**ADDENDUM**

DATE: April 7, 2009
TO: Commissioners and Interested Parties
FROM: South Central Coast District Staff
SUBJECT: Agenda Item Th 9c, Thursday, April 9, 2009; Application No. 4-09-013 (Mariposa)

On Page 4, make the following correction to Special Condition No. 2:

Illustration of Construction Methodology required to meet staff recommendation for Coffor Dam, dewatering removal, grading and replacement of rock.

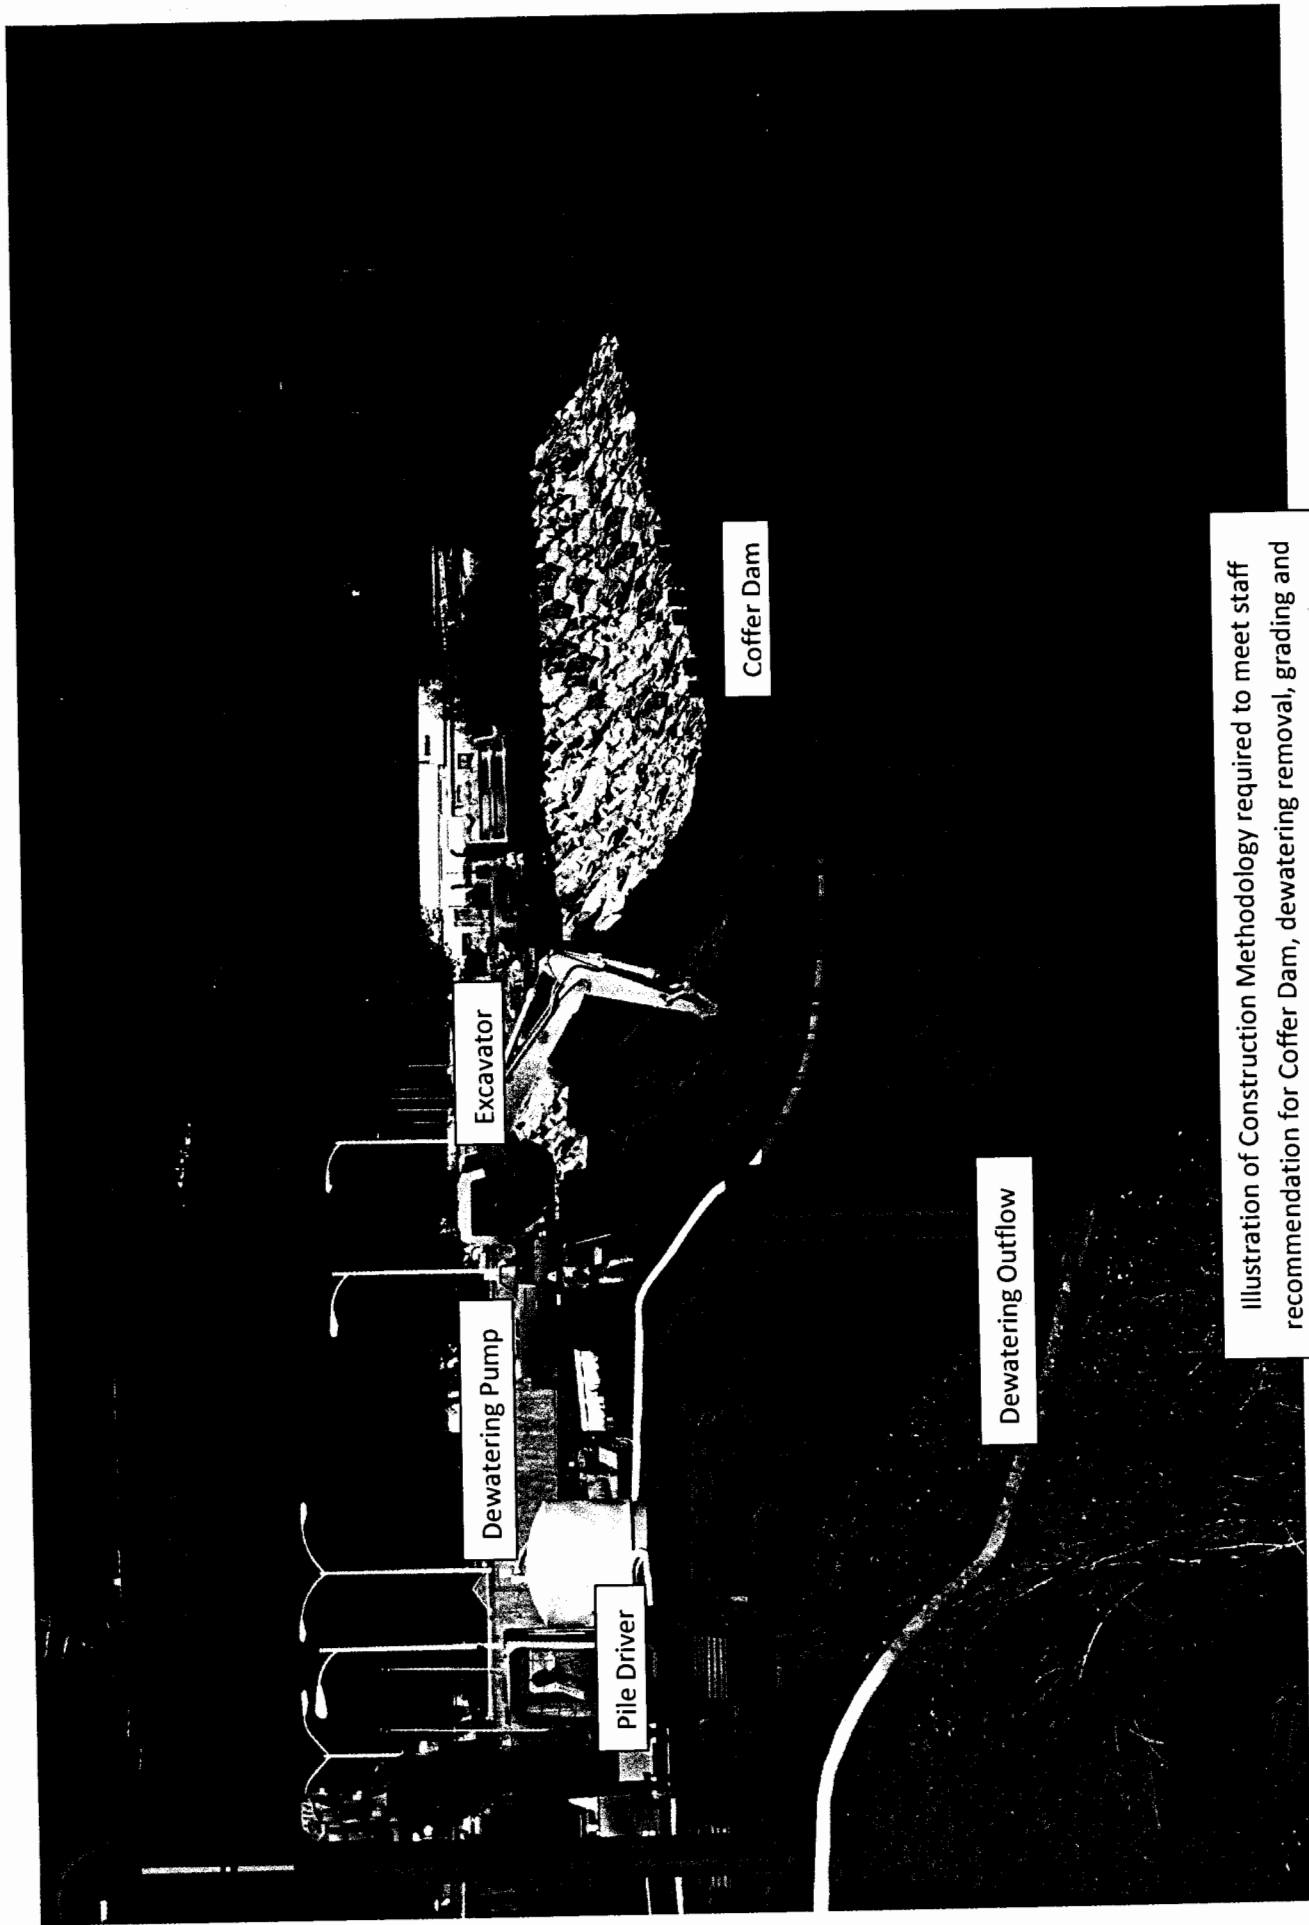
Once the rocks have been removed, large backhoes would grade back the bank to the Staff's desired 2 to 1 slope. Then a filter blanket would be laid over the bank and the rocks would be returned. In order to avoid damage to the filter blanket, placing the rocks is again more difficult than the original 1998 placement. Willow plantings through holes cut in the filter blanket would then be done as mitigation. The coffer dam would be removed. This is generally done by vibrating the piles to loosen the piles from embedding in the creek bottom. An illustration of the elements necessary to carry out the Staff Recommendation is included as Applicant's Exhibit, Tab 3, where the coffer dam, various heavy equipment and dewatering pumps are shown.

EXHIBIT 6

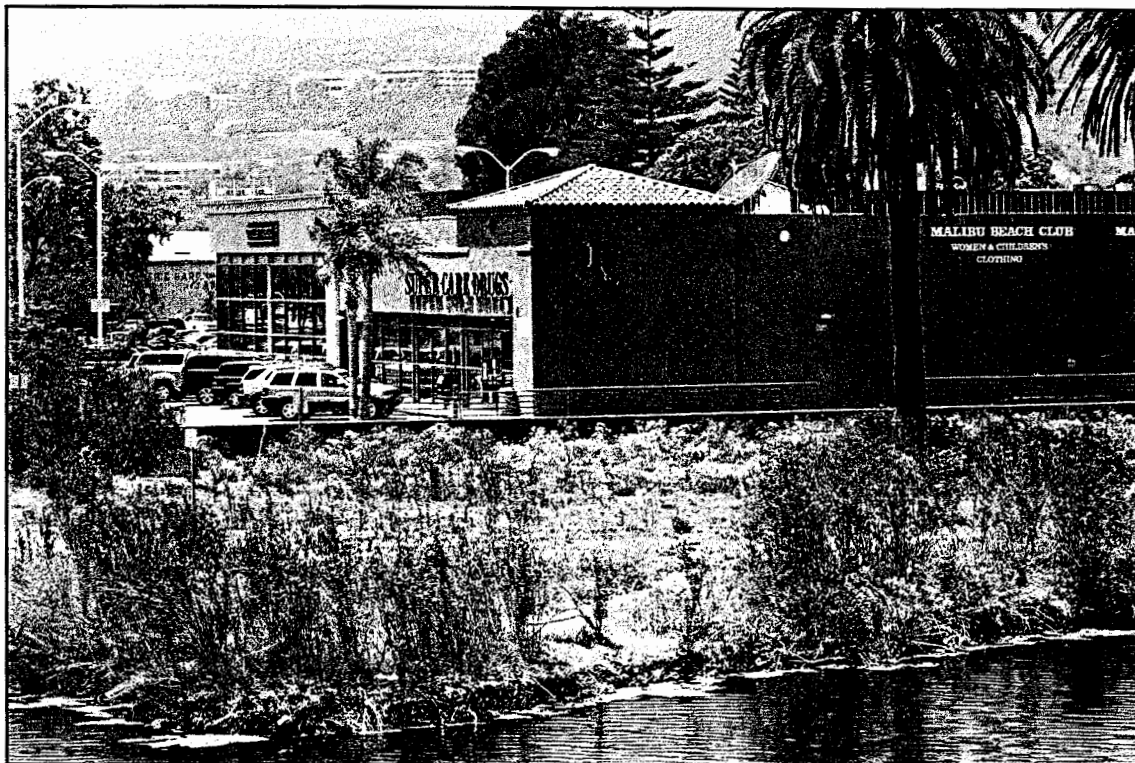
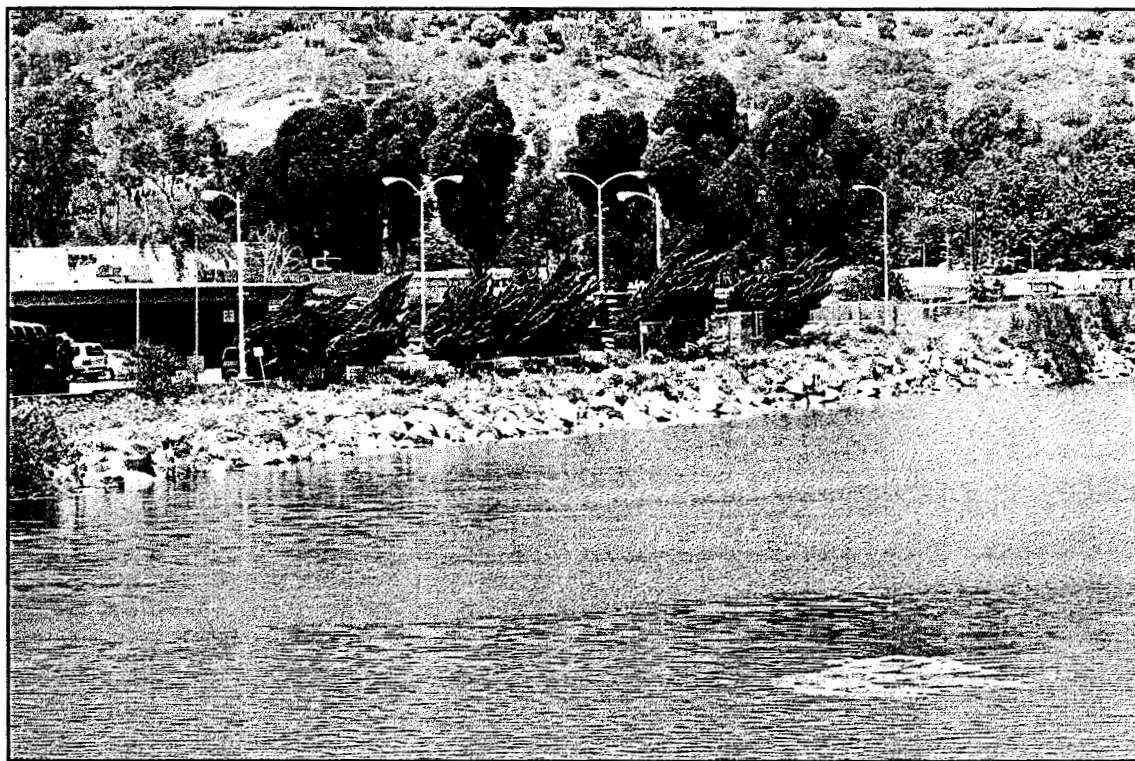
The 1:1 slope was a figure mentioned prior to the survey by Edward P. Sternagle, a licensed surveyor, who determined the true slope, which in part is closer to a 1.7:1 angle. What Dr. Engle did not mention is that the mulefat shrubs that revegetated part of the stream bank are in areas that received sufficient sunlight for the seedlings to become established. The angle of the slopes and the depth of the rip rap in other parts of the stream bank preclude sunlight from penetrating to where seedlings might germinate, thereby not allowing the seedlings to photosynthesize, the process whereby the nutrients are produced for the developing seedlings.

Exhibit 6
4-09-013 (Mariposa)
Surveyed Site Plan with Cross Sections

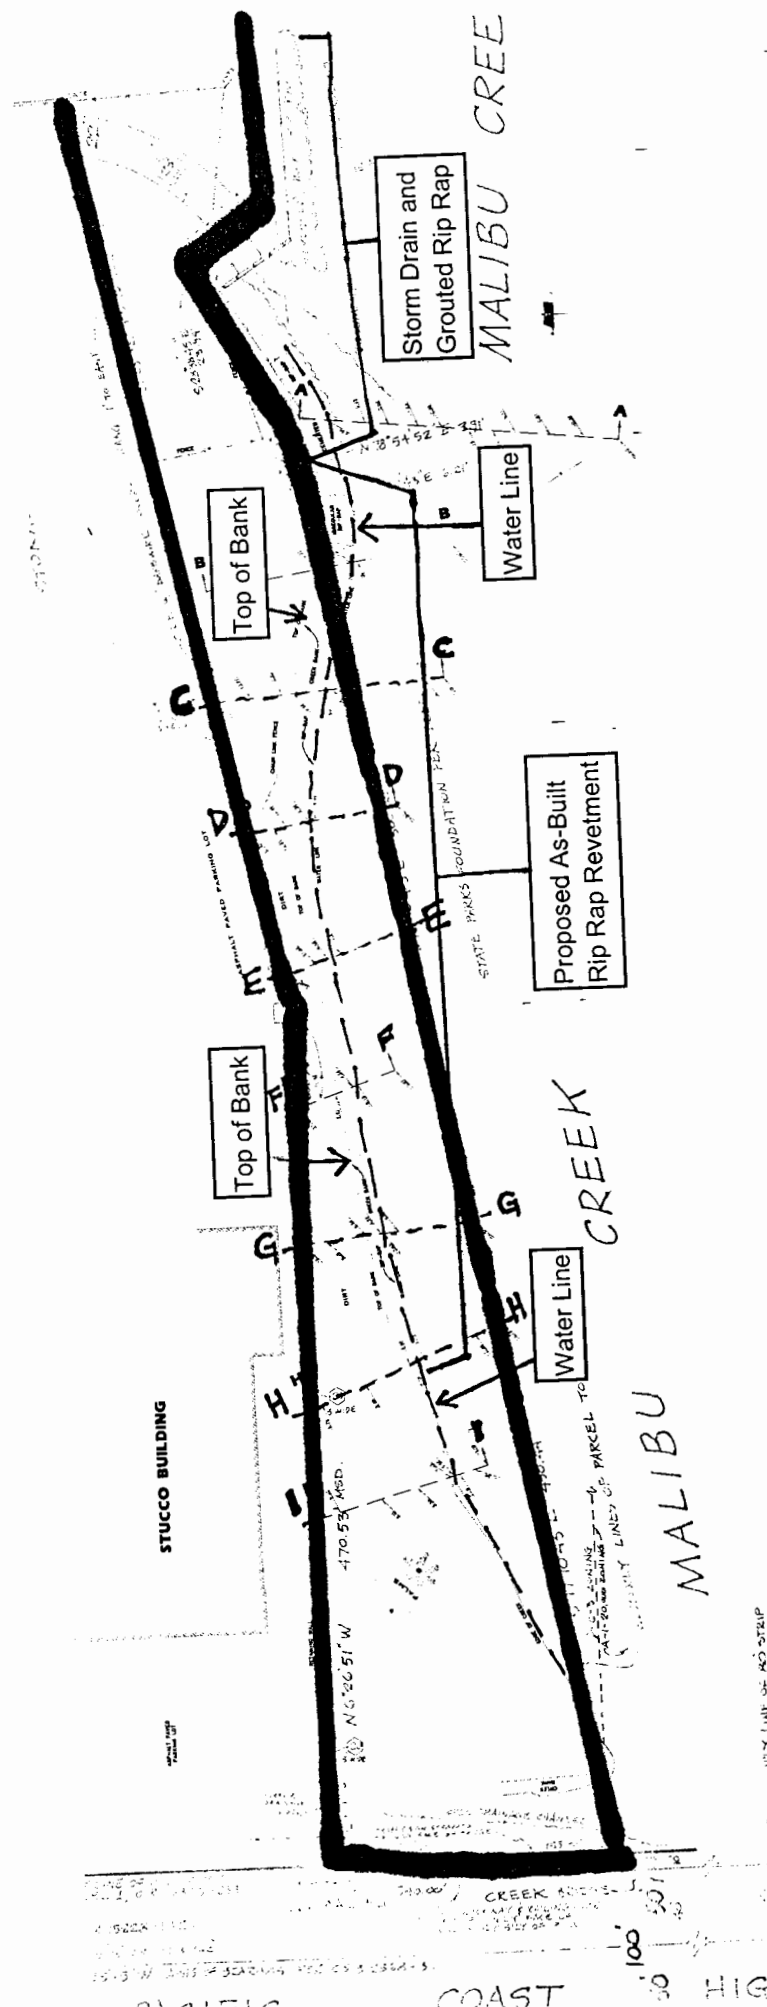
The Staff Alternative is based upon a theory that having the rocks at a slope not greater than 2 to 1 will be more like a natural bank and will enhance the potential success of the mitigation measures. The Staff claims that the majority of the rock is placed at 1 to 1 slope angle. This figure was taken from an estimate based on personal observation by a consulting biologist in 2000. This observation was demonstrated to be inaccurate, but it is cited repeatedly, and wrongly, as true. In 2008, the staff required a detailed survey of the rock bank protection. This was performed by David Grimes, a licensed surveyor with Grimes Engineering. The survey showed that the majority of the rock was laid at an angle closer to 1.7 to 1 with the steepest at 1.3 to 1 and the least at 2.1 to 1. Engineer David Jaffe made the slope calculations which are shown on Applicant's Exhibit, Tab 2. A comparison of the Staff Calculation of slope as shown on Staff Report Exhibit 6 is contained on the engineer's calculations and in each case shows the Staff calculation to have exaggerated the slope of the existing rock.

The maximum distance at any point is 10.9 feet. All of this tremendous work required by the Staff moves the top of the rocks moved an average of 52 inches. It seems almost axiomatic that such a small change has no real environmental benefit. When weighed against the adverse environmental effects, the Commission should see that a reasonable mind would simply say the existing rocks should stay in place.

1. That the rock slope protection has been re-engineered to be laid back to a slope no steeper than 2:1 (H:V). However, the toe of the slope protection shall not extend further into the creek than currently exists. If determined feasible, the footing portion of the rock slope protection may remain in place and only the upper portion of the rock shall be laid back to a slope no steeper than 2:1.
2. That geotextile filter fabric (~~biodegradable, non-plastic~~) and live willow stakes are incorporated into the re-engineered rock slope protection during construction, consistent with the Revised Revegetation Plan required as part of Special Condition No. 3 below.
